Appendix 5: Changes to Strategic Sites

A5.1 Introduction

A5.3 Strategic Sites – Detailed Proformas and Maps

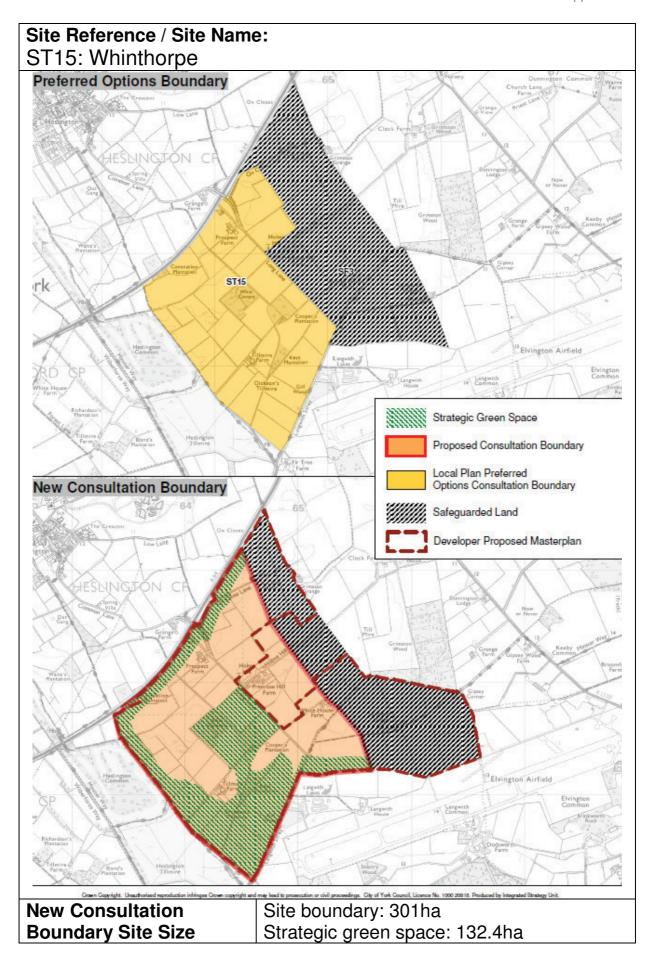
Site promoters proposed a revised 178 hectare site, with a masterplan boundary which extended the site by around 12 hectares to the west, incorporated around 22ha of the former safeguarded land allocation to the north, and included a new 3.4 hectare parcel of land to the east at the junction of the A1237 and B1363. The proposed site boundary also included strategic greenspace to the southern and eastern boundaries.

Whilst the eastern and part of the western extensions have been included for consultation purposes in this paper, the proposed northern site extension into proposed safeguarded land was considered to be inappropriate. The extent of western boundary extension has also been reduced in the plan opposite to around 6.8ha (as opposed to the 12 hectares originally proposed) in order to explore options to mitigate heritage and landscape impacts.

The 12 hectare western boundary extension was proposed to 'present a softer edge rather than following field boundaries'.

In greenbelt/ heritage impact terms, the eastern and western boundaries are sensitive due to the issues of setting of the City in a rural hinterland, and coalescence of settlements.

Adequate undeveloped and landscaped buffers must be retained east and west of the site in order to prevent coalescence with adjacent settlements and maintain the setting of the City, particularly in terms of views from the Outer Ring Road and PROW network. Pulling the western site boundary proposed by site promoters away from Skelton reduces the greenbelt impact of the development, and produces a development area that is more capable of being screened by existing landscape features. In considering the final allocation and strategic open space boundaries, significant landscaping on this boundary would reduce the physical and visual proximity of the development area to Skelton; a woodland buffer would integrate well with existing landscape features and perform this screening/ distancing function.

Migration of the site northwards to create a substantial landscape buffer could be beneficial in making the development more legible in terms of the York narrative of City within rural hinterland, though given the existing built up nature of the Clifton Moor area, development to the A1237 would be less sensitive here than in other locations. The landscape and development approach should be capable of accommodating eventual dualling of the outer ring road in the vicinity of the site, without harm to any screening.

Although the principle of development on safeguarded land north of the original site was set out in the Preferred Options plan, this area has a sensitive relationship with Skelton Moor. Given anticipated lead in times and delivery rates at the site, it is considered that, with the western boundary changes proposed, the allocation area will be sufficient to optimise site build-out in the plan period.

Proposed boundary changes do not appear to present major flooding and drainage showstoppers, though implications for existing watercourses will

| require close liaison with the drainage board. | | |
|--|---|--|
| Recommendation: | To include the revised boundary to ST14 to reflect the need for a strategic landscape buffer around the site for inclusion within the Local Plan. | |
